ADDENDUM #2
NWIT-14-40
2014 Sewer Rehabilitation Program – CIPP Relining
New Westminster, BC

**CITY OF NEW WESTMINSTER
CONTRACT No. NWIT-14-40
2014 SEWER REHABILITATION PROGRAM – CIPP RELINING**

ADDENDUM No. 2

Project No: D-14660-00
 Scale: AS SHOWN
 Design No: D-14660-00 CIPP G2-G10
 Sheet No: G5
 Revision: C

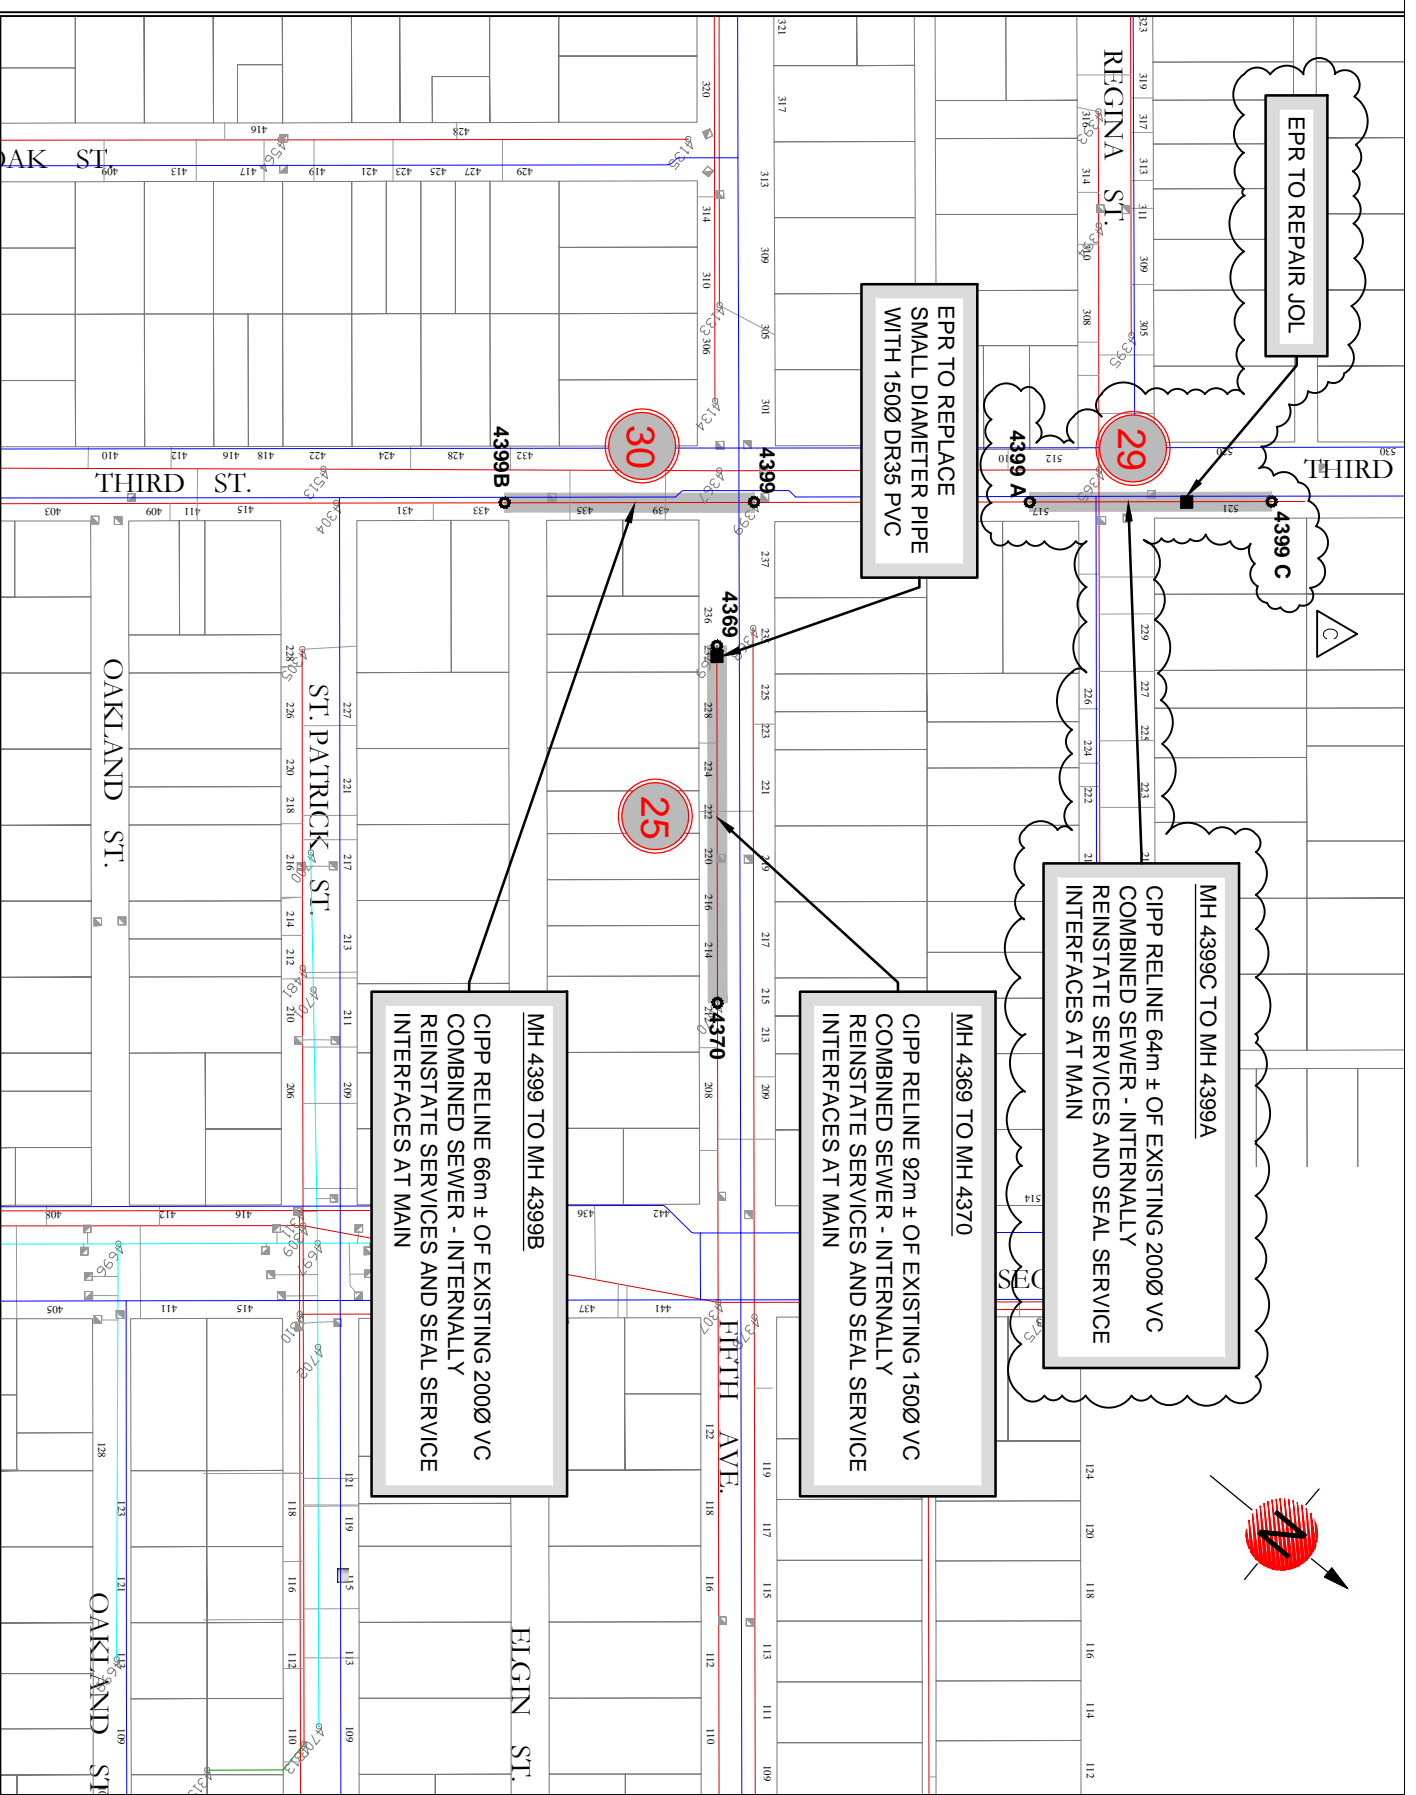
Replace: Drawing G5, Revision B, "Issued for Construction"

With: Drawing G5, Revision C, "Addendum #2" – attached to this addendum

NOTE: Rehab #29 is now from MH4399C to MH4399A and is located on Third Street, north of Fifth Avenue.
